III. Revisions, Clarifications, and Corrections to the Draft EIR

This section of the Final EIR provides changes to the Draft EIR that have been made to revise, clarify, or correct the environmental impact analysis for the TVC 2050 Project (Project). Such changes are a result of public and agency comments received in response to the Draft EIR and/or additional information that has become available since publication of the Draft EIR. The changes described in this section do not result in the Project creating any new or increased significant environmental impacts.

Figure II-3(a)
Potential Outdoor Production Activity Areas
Existing Conditions

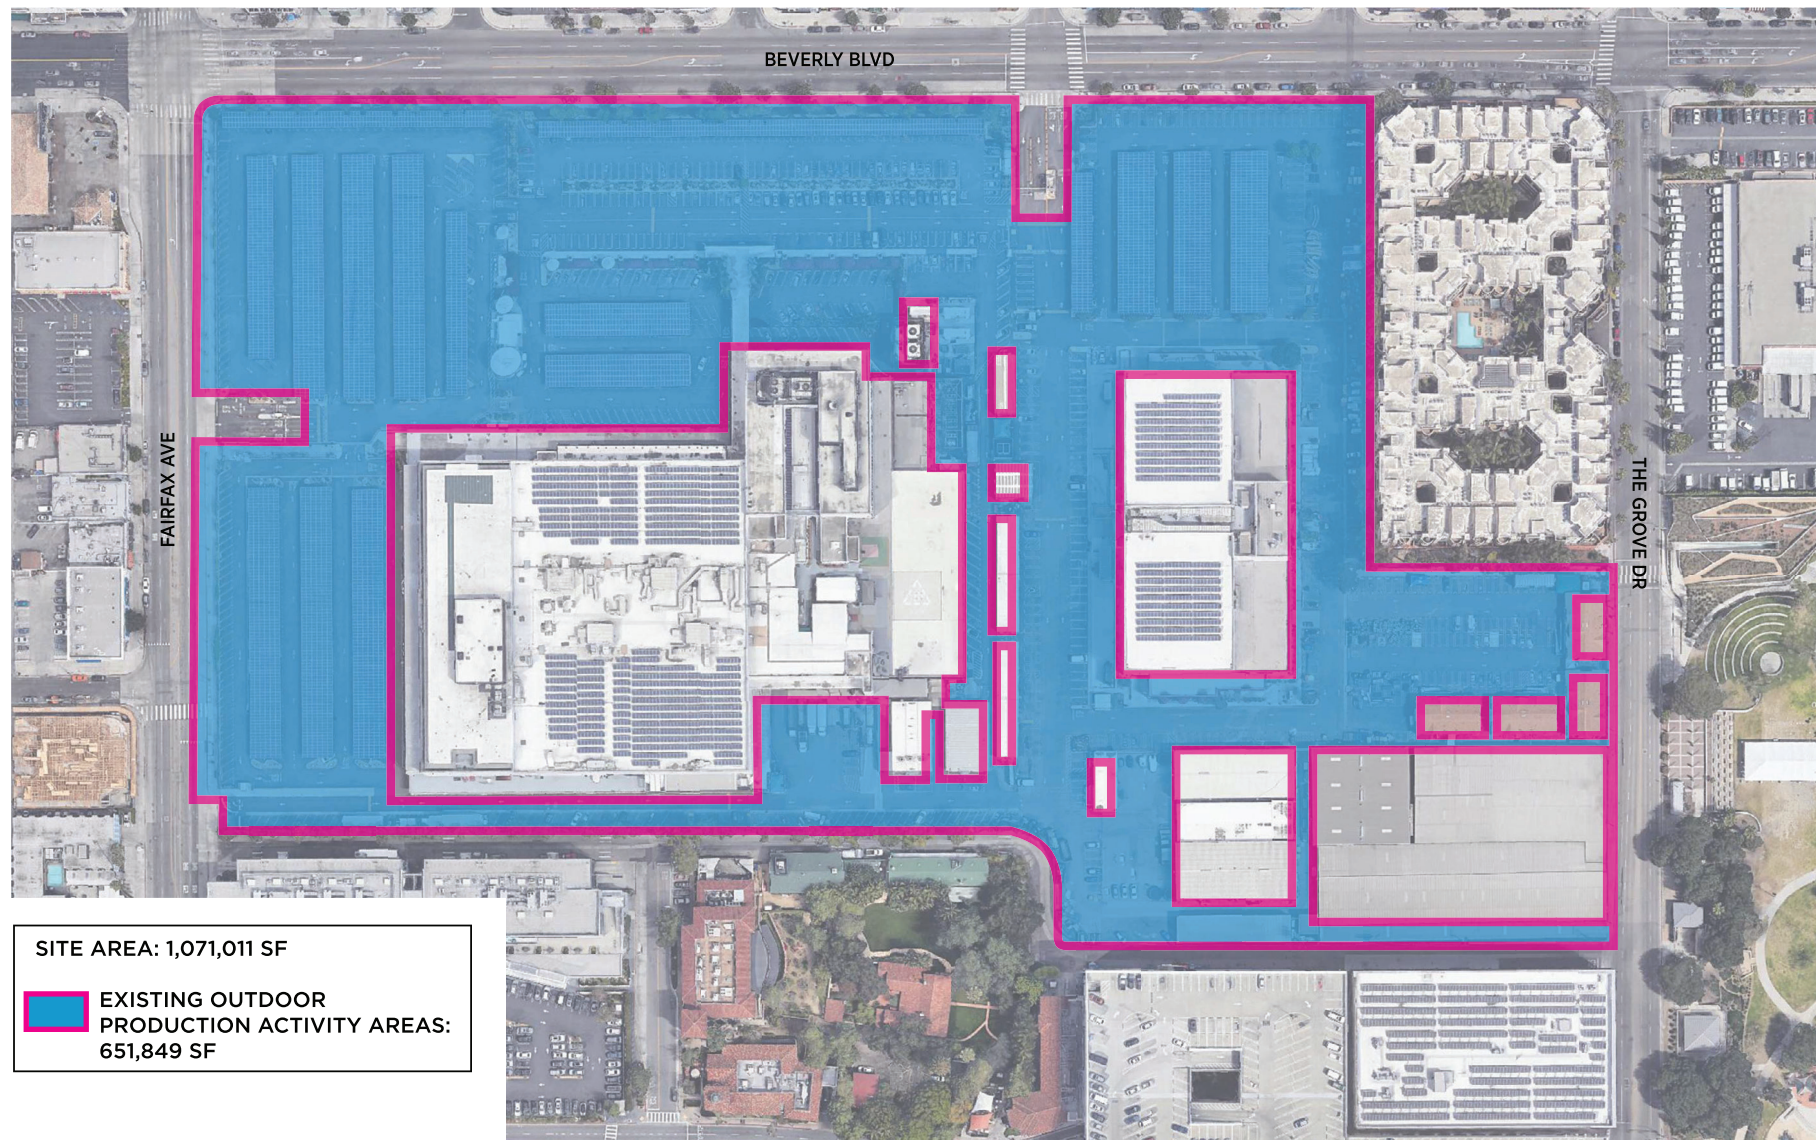
Existing outdoor production activity areas comprise approximately 651,849 square feet and are located throughout the Project Site as shown in Figure II-3(a) on page III-5 of the Final EIR. Basecamps, which are a subset of the outdoor production activity areas, are defined areas at, near, or within a filming location where critical production activities can be coordinated. These existing basecamp areas comprise approximately 177,000 square feet and provide for active uses (including, but not limited to, loading, wardrobe, hair, make-up, craft service, etc.) and passive uses (including, but not limited to, parking, storage of mobile facilities, small portable power generators, support vehicles, etc., all related to production activities. ~~Within~~ As shown in Figure II-3(b) on page III-6, within the Project Site, basecamp activities typically occur within existing surface parking areas and other open space areas.

Figure II-4(d)
Basecamp Areas at Project Grade - Future Conditions

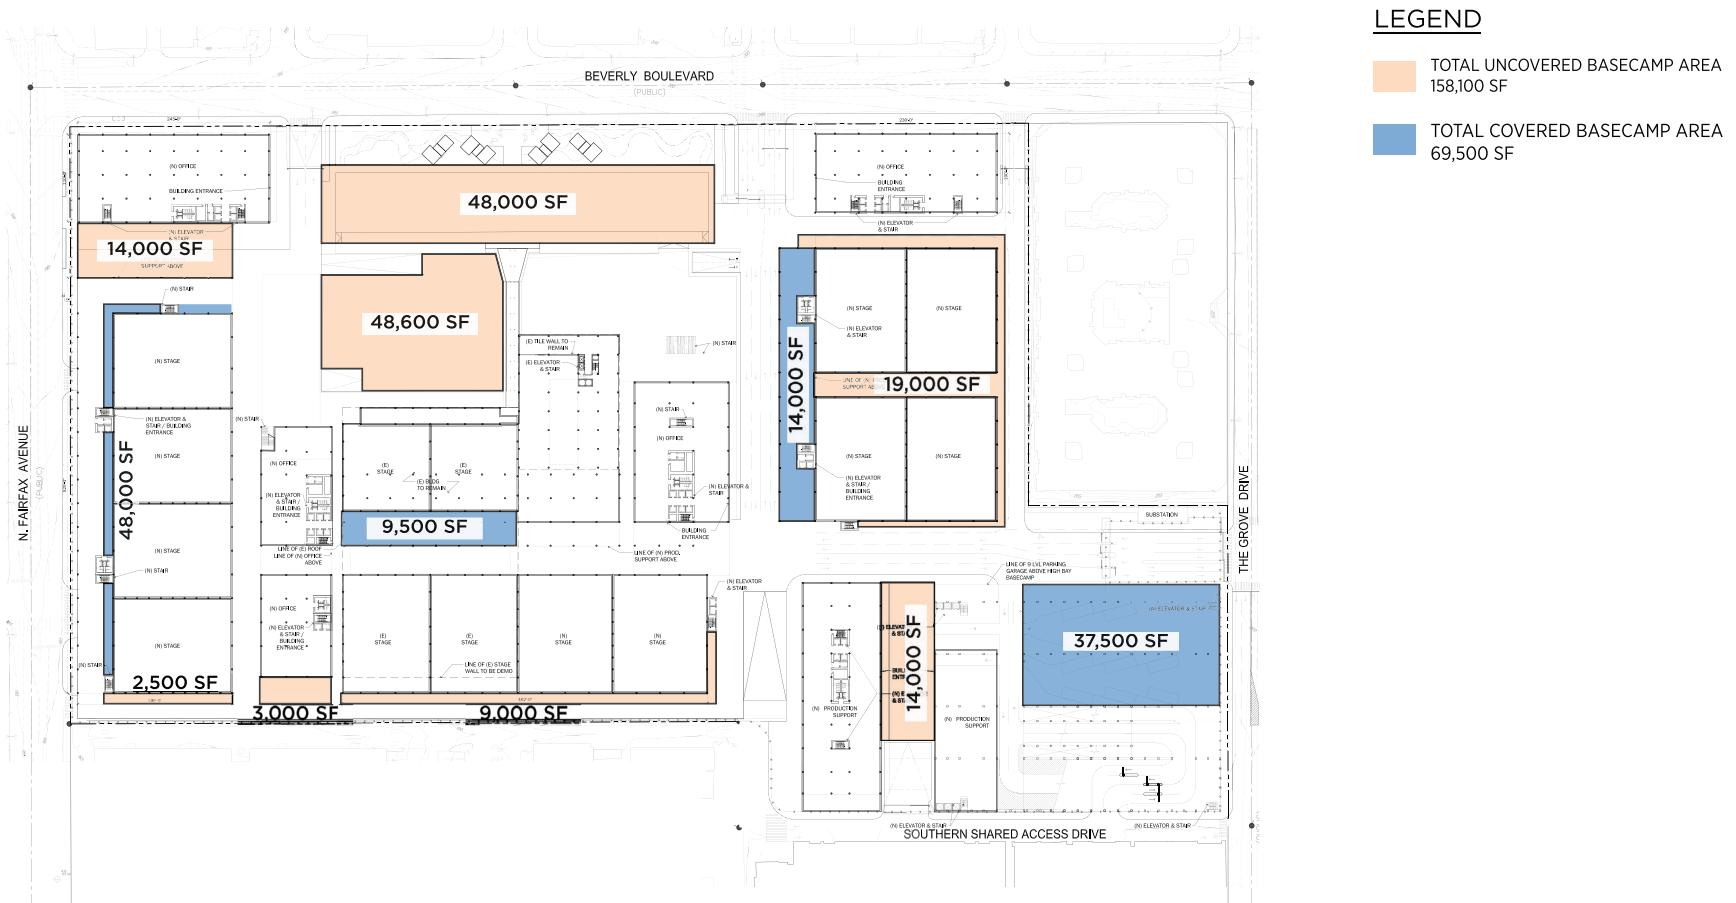
square feet of basecamp areas. As shown in Figure II-4(d) and Figure II-4(e) on pages III-14 and III-15 of the Final EIR, these basecamp areas would be located below and at Project Grade. These basecamp areas would include the same uses and functions as existing conditions, with the exception that small portable diesel and gasoline generators would no longer be used.

Figure II-10 (Revised)
Proposed Signage Plan

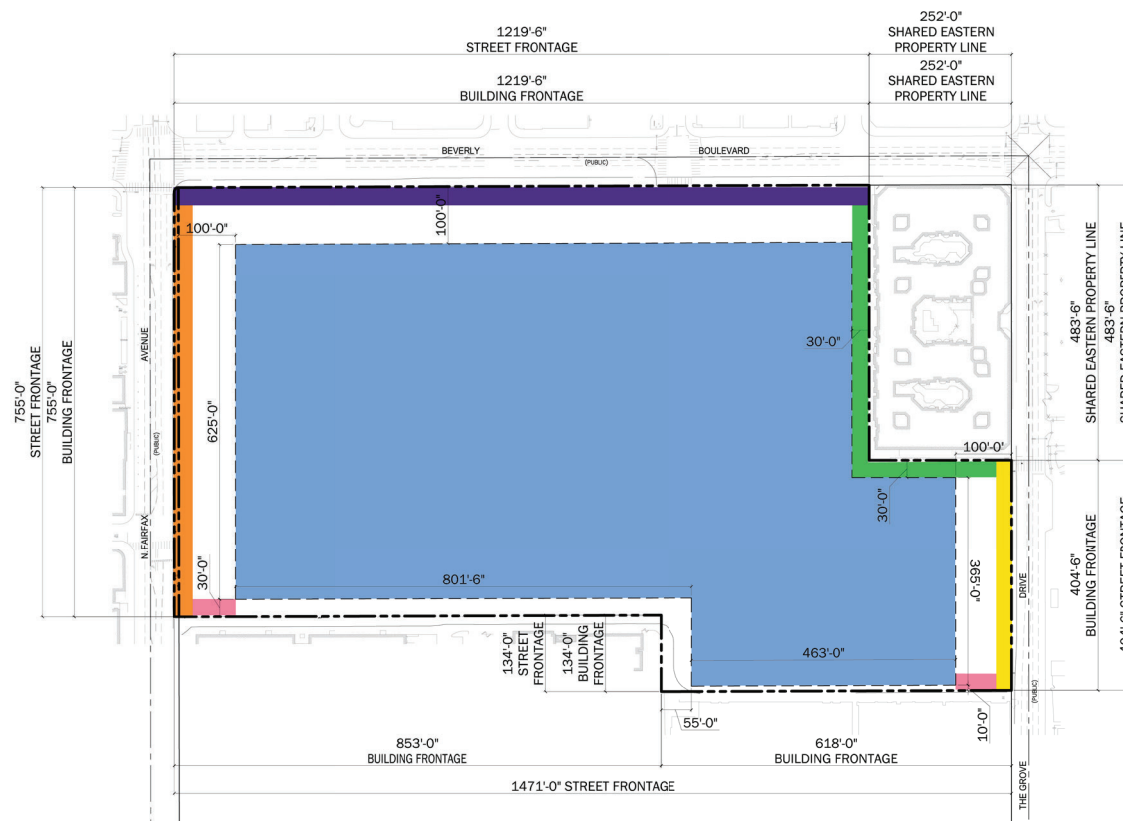
As shown in Revised Figure II-10 on page II-32, III-20 of the Final EIR, the proposed Sign District would regulate signage along the Project Site perimeter, as well as interior signage. A total of approximately 31,375 square feet of signage is proposed around the Project Site perimeter, with the exception of the Shared Eastern Property Line in the northeast corner of the Project Site facing Broadcast Center Apartments, where signage would be limited to smaller identification, informational, and directional signs of no more than 25 square feet each and located no more than 15 feet above Project Grade. Digital displays would not be permitted along the Project Site perimeter.

Figure IV.F-1 (Revised)
Hazards and Hazardous Materials Site Map

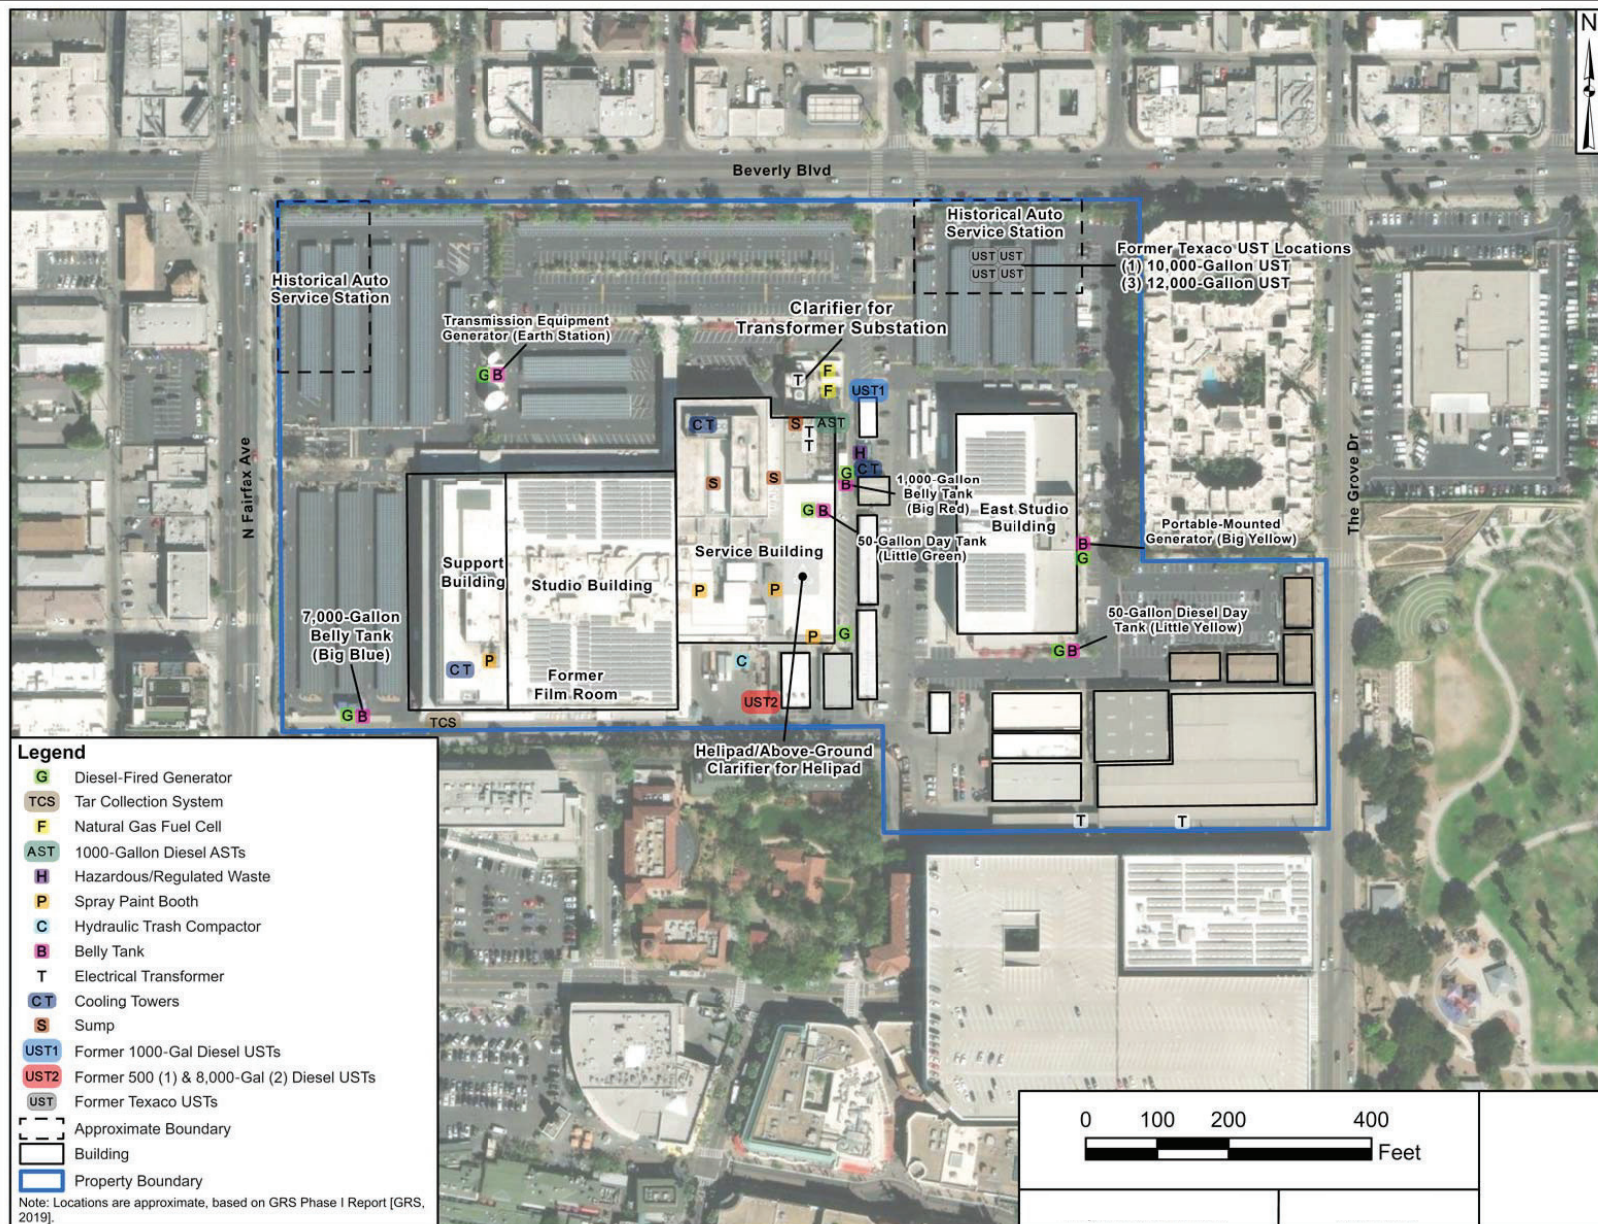
As shown in Revised Figure IV.F-1 on page ~~IV.F-26, III-40~~ of the Final EIR, as part of CBS operations, one 1,000-gallon diesel UST and two 8,000-gallon diesel USTs were installed at the Project Site in 1952, and a 500-gallon diesel UST was installed in 1956, all generally located within the central and southern central areas of the Project Site. Three of the diesel USTs were taken out of service and permanently removed in 1988. Soil sampling was conducted during tank closure, and approximately 750 cubic yards of diesel-contaminated soil was bio-remediated and removed off-site. Groundwater impacted with benzene, toluene, chlorobenzene, ethylbenzene, 1,4-dichlorobenzene and 1,3-dichlorobenzene was identified in the vicinity of the former tanks. Upon completion of the investigations, CBS's environmental consultant, Converse Environmental, indicated the tank

Section IV.F, Hazards and Hazardous Materials, page IV.F-26, replace Figure IV.F-1 with Revised Figure IV.F-1 on page III-40.

Figure IV.G-1 (Revised)
Proposed Site Drainage

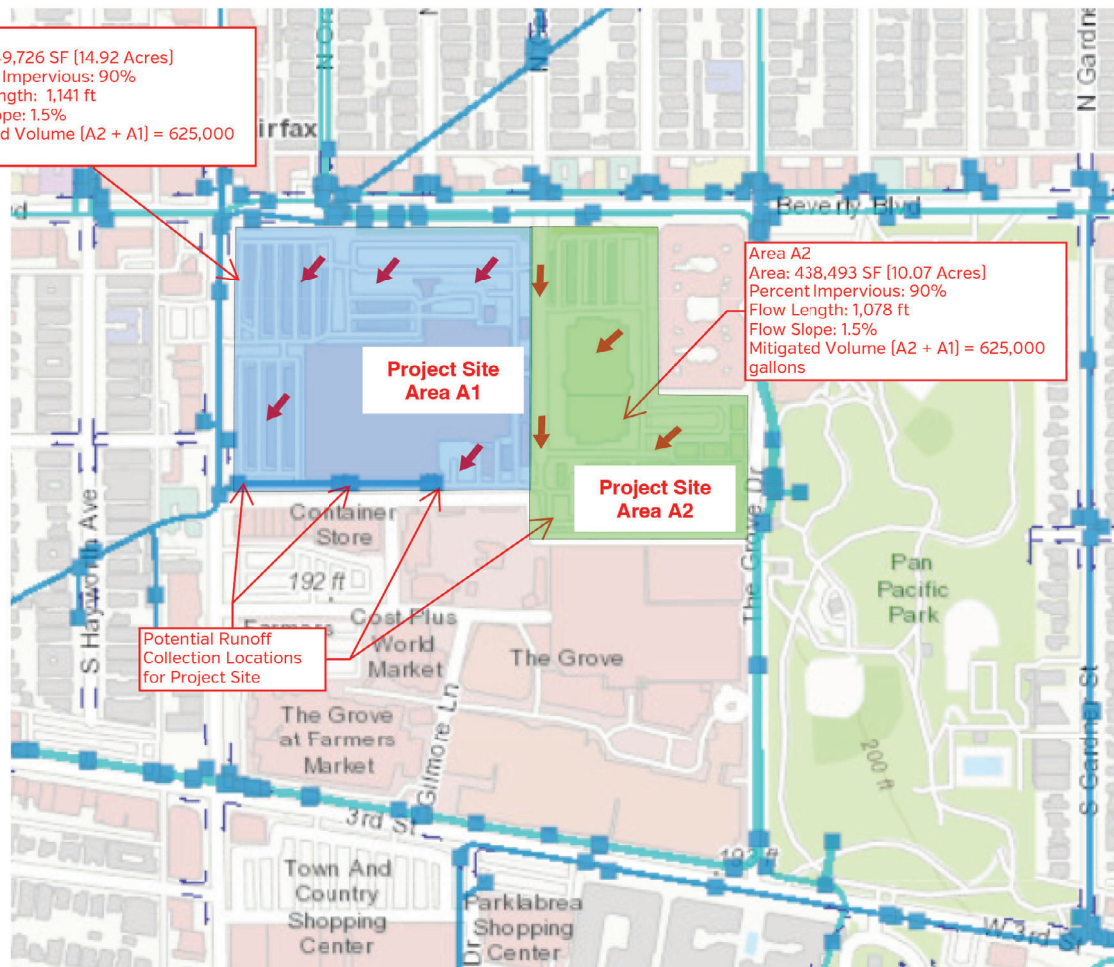
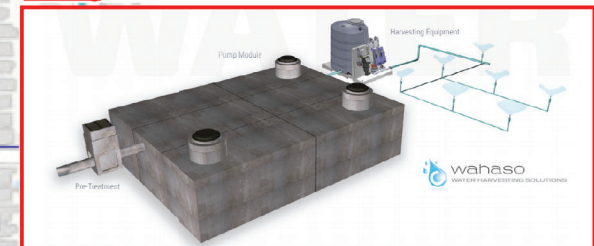
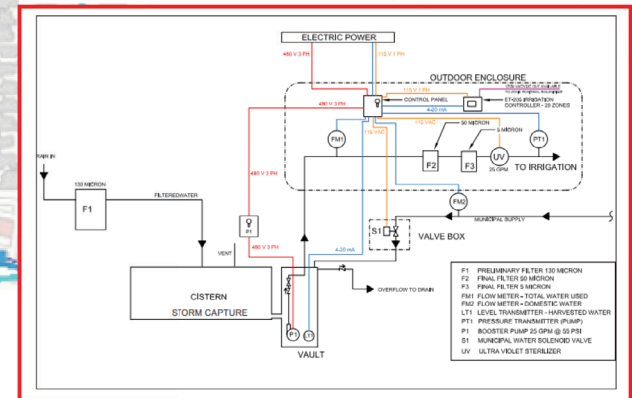
Section IV.G, Hydrology and Water Quality, page IV.G-21, replace Figure IV.G-1 with Revised Figure IV.G-1 on page III-42 of the Final EIR.

As illustrated in Revised Figure IV.G-1 on page ~~IV.G-21~~, III-42 of the Final EIR, the existing drainage areas and overall drainage patterns would remain unchanged as a result of Project implementation. As discussed above, similar to existing conditions, the Project Site would continue to be comprised of up to approximately 90 percent impervious surfaces following Project buildout. As such, there would be a limited potential for erosion or siltation to occur from exposed soils or large expanses of pervious areas. In addition, as determined in the Hydrology Report and as summarized in Revised Table IV.G-1 on page ~~IV.G-36~~, III-43 of the Final EIR, the overall surface water flow rate would not change with implementation of the Project. Specifically, existing runoff flows during a 50-year storm event are 53.4753 cfs.³² As shown in Revised Table IV.G-1, runoff flows during Project operation would remain the same at 53.4753 cfs during a 50-year storm event. Accordingly, there would be no increase in runoff volumes into the existing storm drain system. Furthermore, the Project's stormwater infrastructure would be designed to convey the 50-year storm to the designated discharge location. Inlets within the Project Site would be sized to

Figure IV.H-6 (Revised)
The Grove Drive Public Realm Improvements

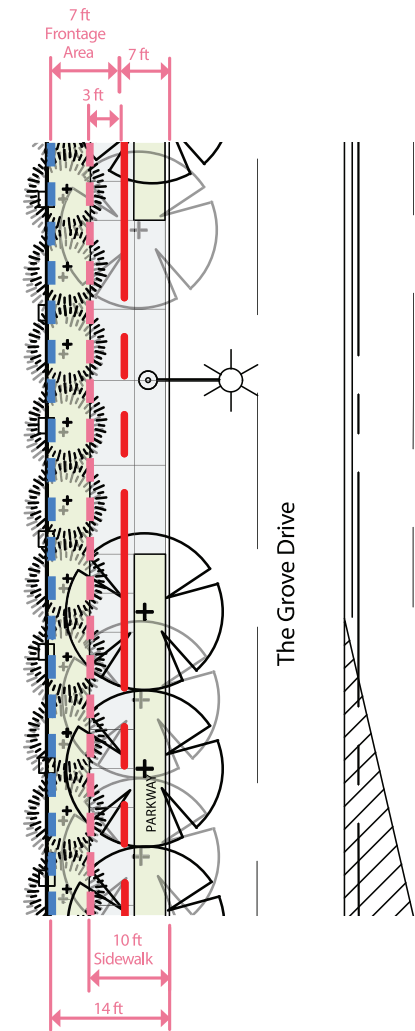
The proposed public realm improvements along each Project Site edge are described further below and are illustrated in Figure IV.H-3 through ~~Figure IV.H-6~~ Figure IV.H-5 on pages IV.H-33 through ~~IV.H-36~~ IV.H-35 and in Revised Figure IV.H-6 on page III-49 of the Final EIR.

Section IV.H, Land Use and Planning, page IV.H-36, replace Figure IV.H-6 with Revised Figure IV.H-6 on page III-49.
